Agenda Item	6.5
Report No	PLS-50-23

**Committee:** South Planning Applications Committee  
**Date:** 23 August 2023  
**Report Title:** 23/01607/LBC: Network Rail  
Kingussie Railway Station, Ruthven Road, Kingussie PH21 1EN  
**Report By:** Area Planning Manager – South

**Description:** Installation of footbridge with associated lifts and removal of existing footbridge  
**Ward:** 20 – Badenoch and Strathspey

**FOOTBRIDGE DECK STRUCTURE  
GENERAL ARRANGEMENT**

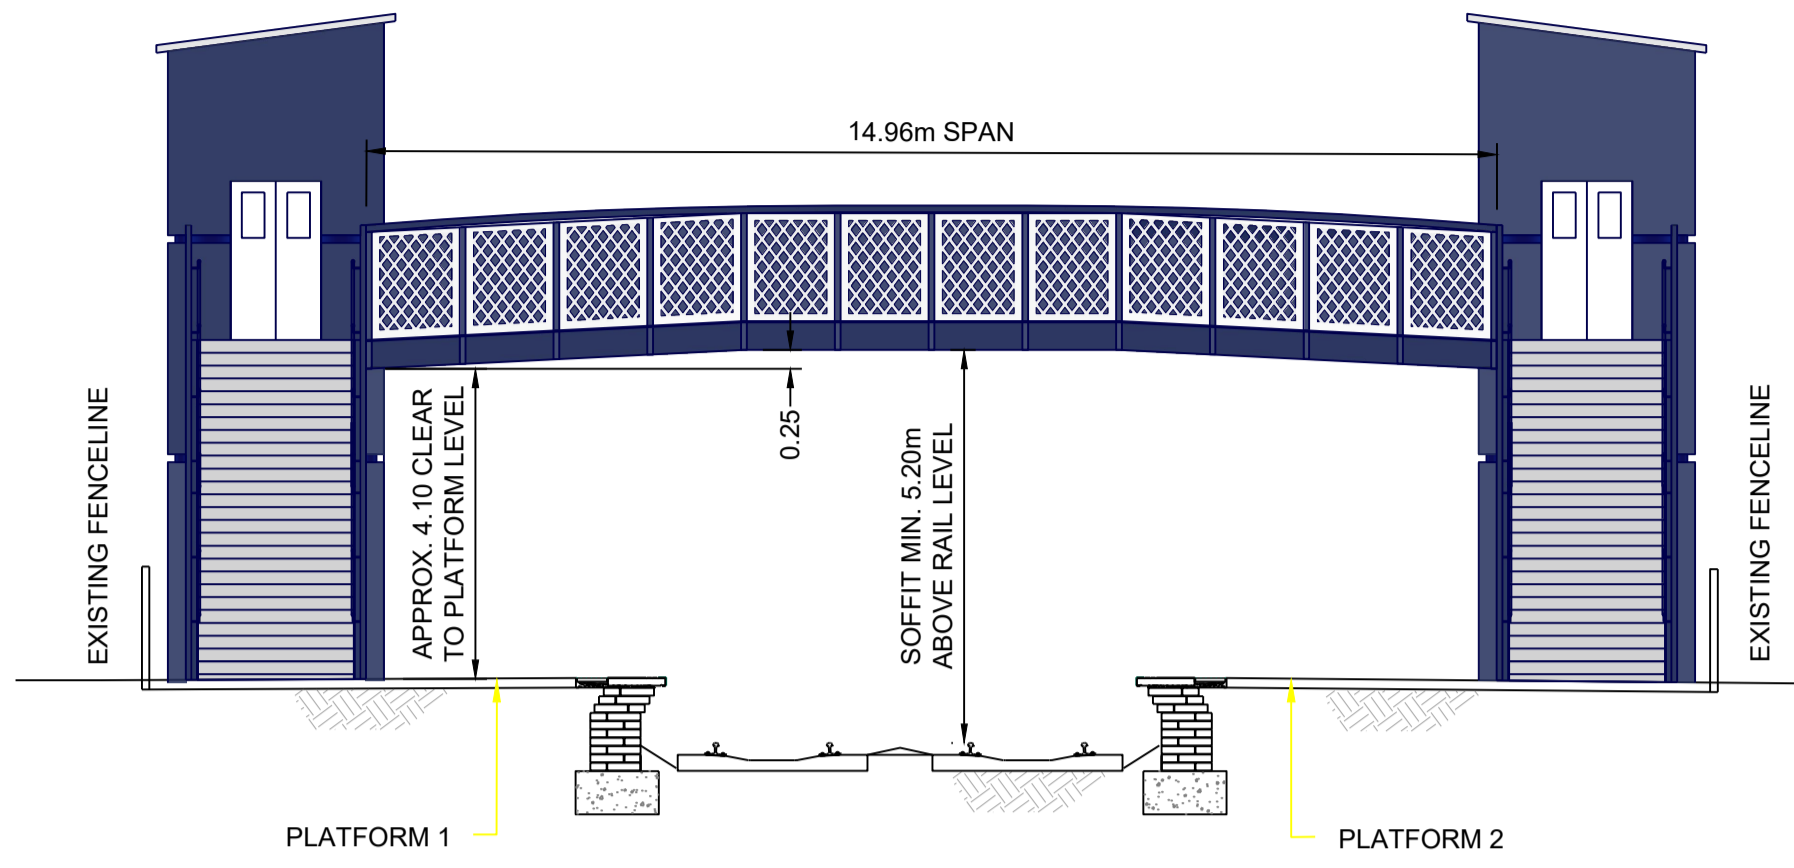
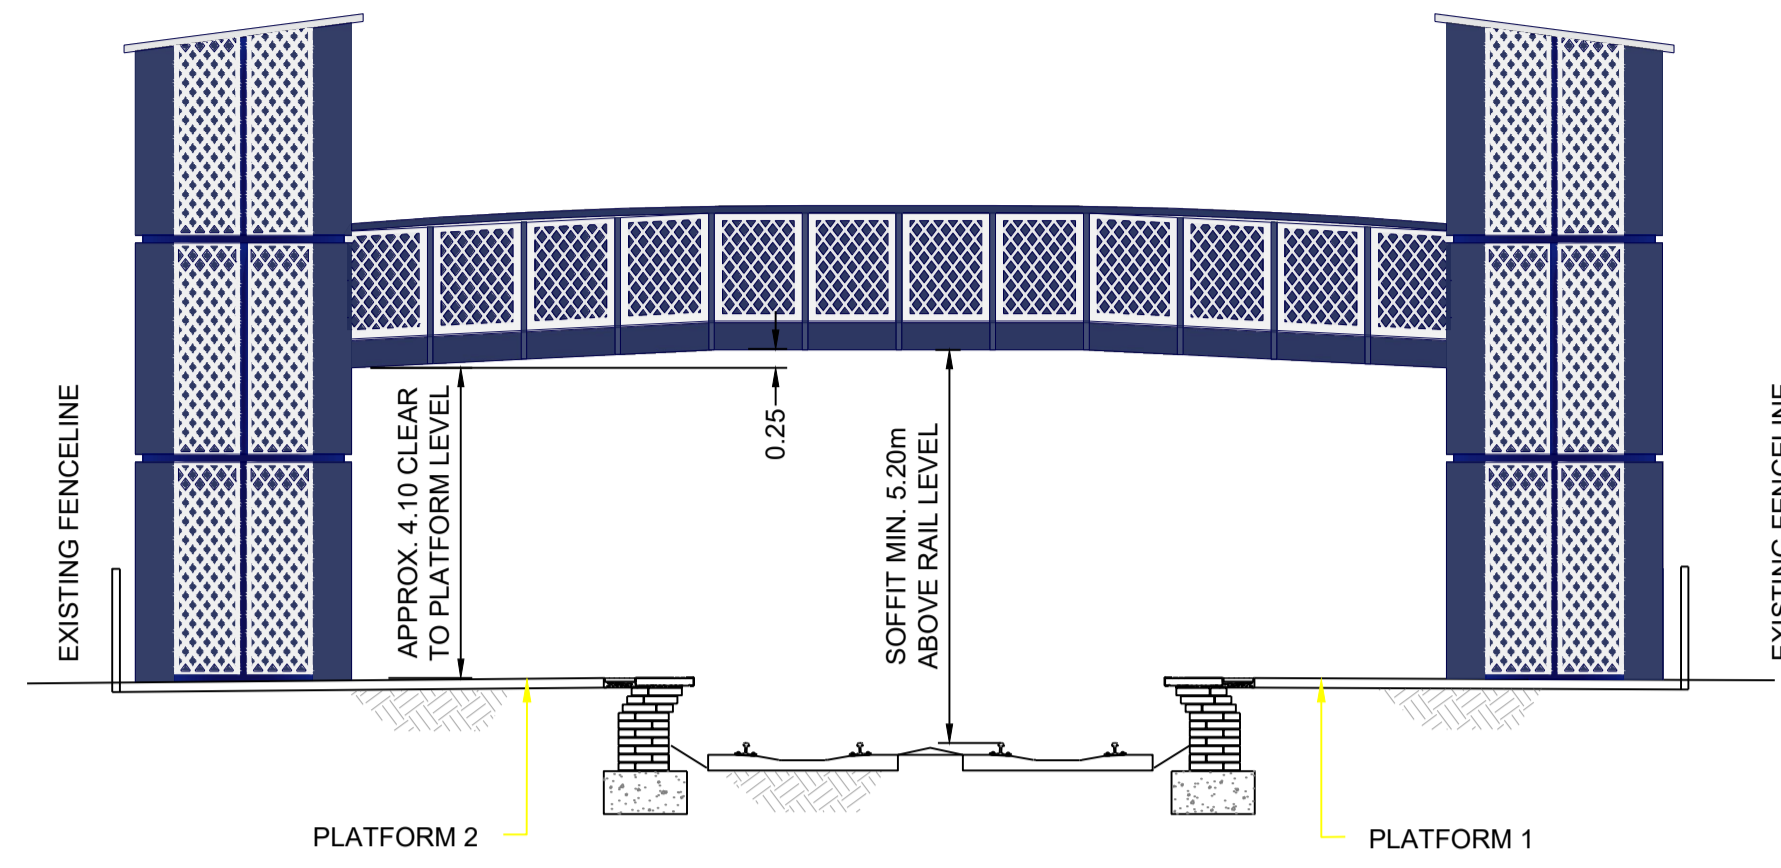
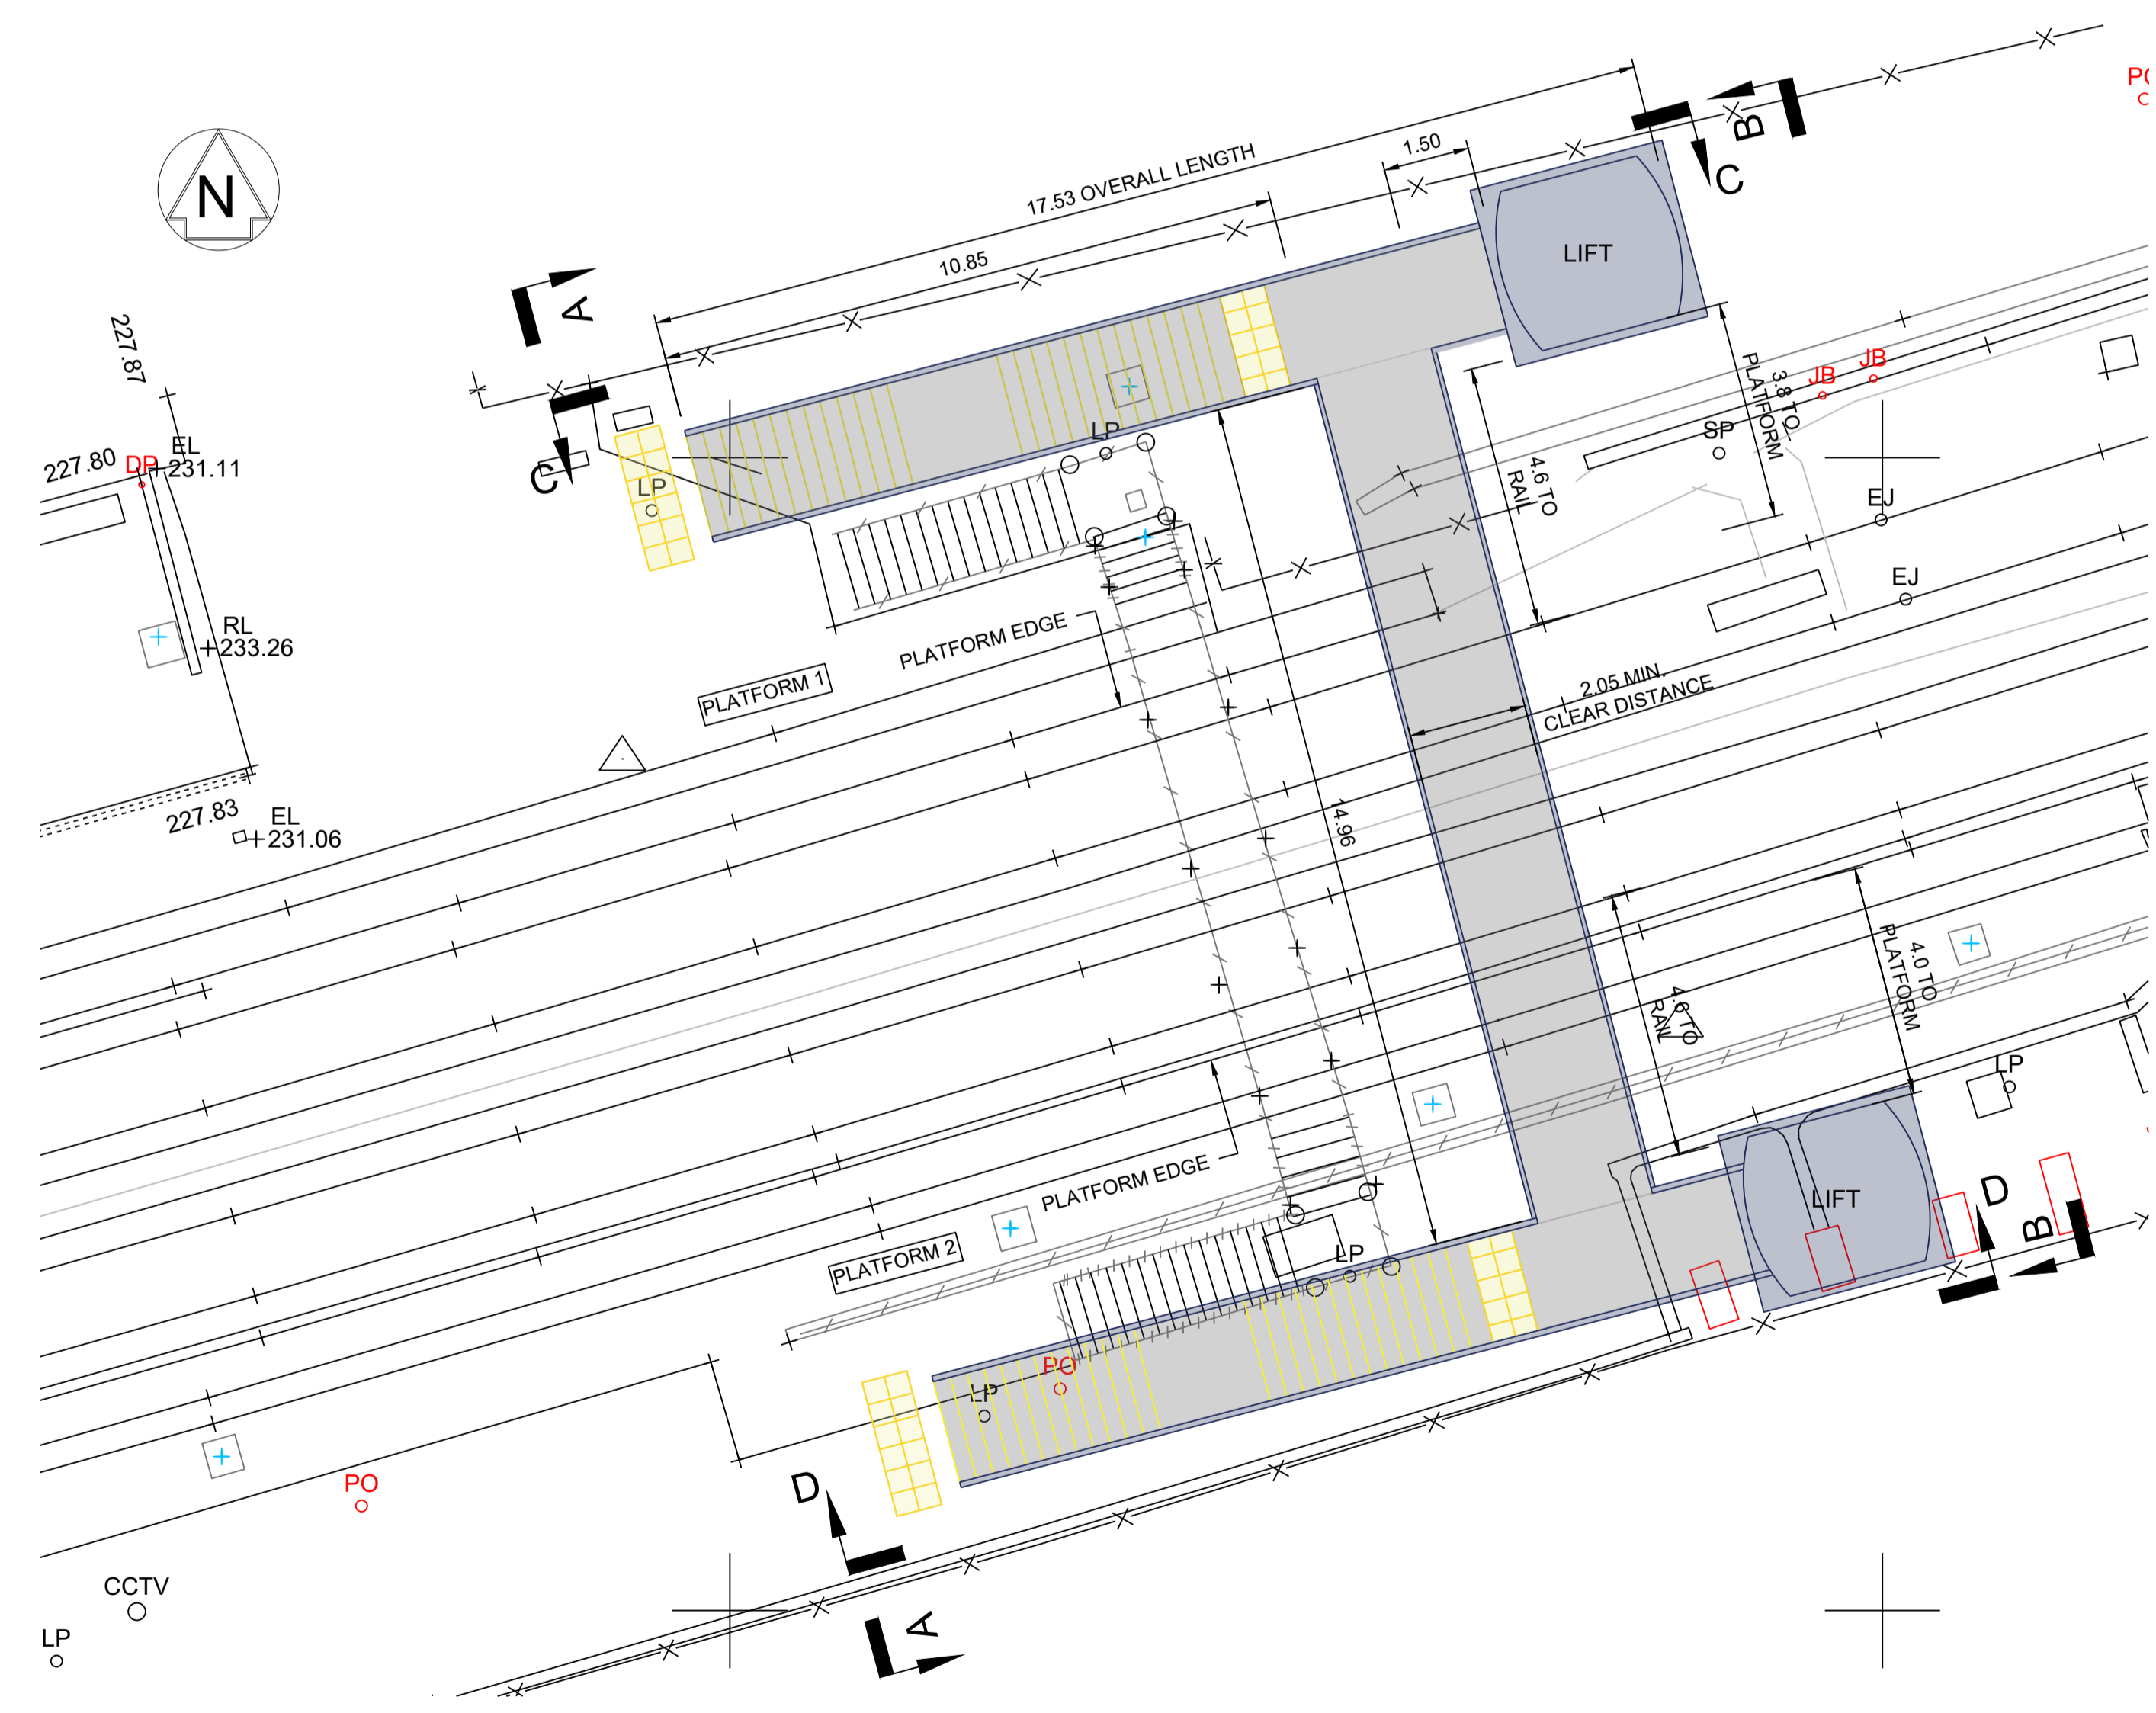
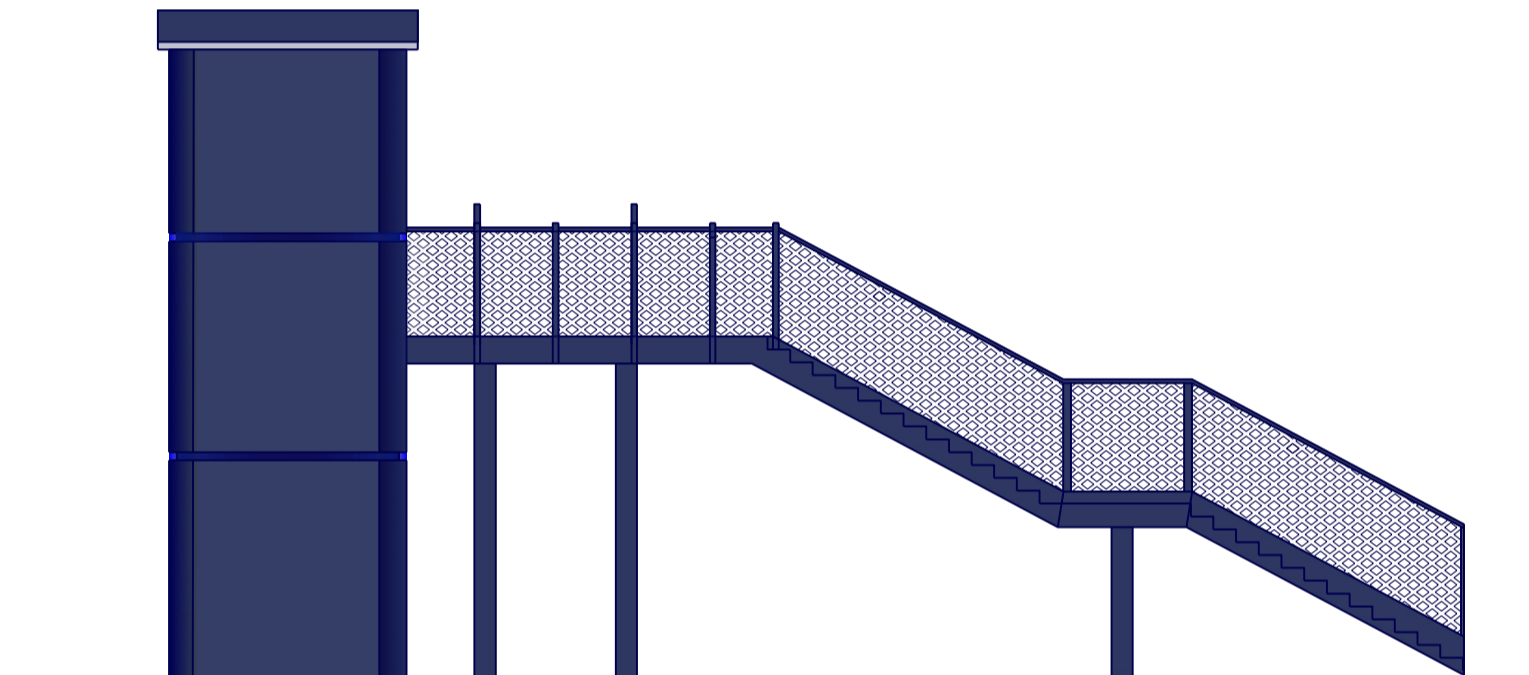
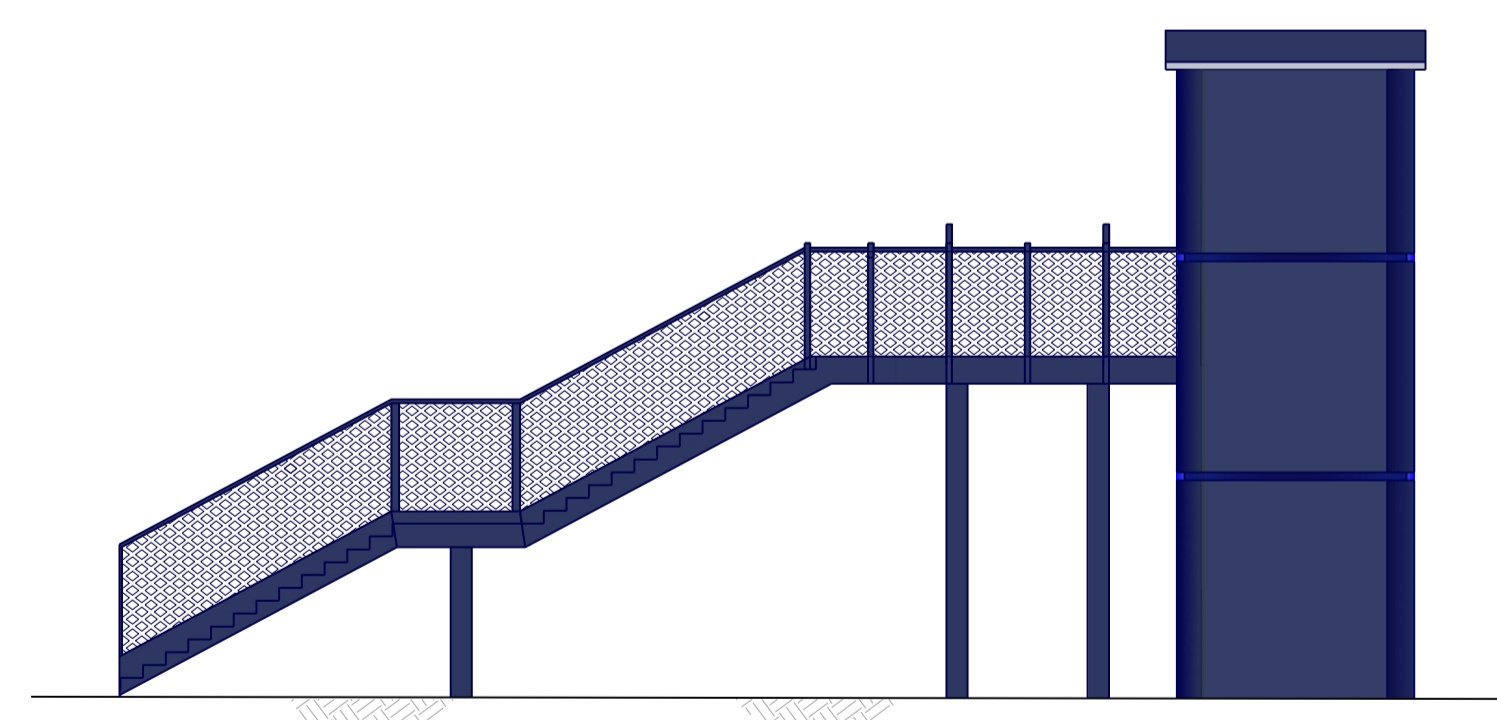
- 8.11 Station Master's House was not considered as 'listed' by the submitted Heritage Statement. As noted in section 2.1 above, it is considered that the original Station House is curtilage-listed to the Station group. This is a fundamental issue for the assessment of this proposal. The positioning of the proposed bridge, so close to the Station House, is entirely adverse and obtrusive, where the bridge and its lift-towers will dominate the setting of Station House; the negative impacts upon the character and integrity of the historic house will be overwhelming and therefore cannot be supported.

9.1 The proposal is for the removal of the existing (B-listed) footbridge and its replacement with a larger structure, incorporating a lift at either side. The increased scale of the new bridge takes the overall footprint further to the east than the existing.

1. The location of the proposed new footbridge, within the B-listed Station group, will have a significantly adverse impact on the group's historic character,

The maps and elevation drawings associated with this application do not even acknowledge the existence of Station House.

The concept schematics do not acknowledge the existence of Station House

Network Rail has stated that the new crossing should be empathetic to the surrounding buildings and be of an appropriate and sympathetically recessive colour scheme", shown on the schematics as a large dark grey structure of modern building materials.
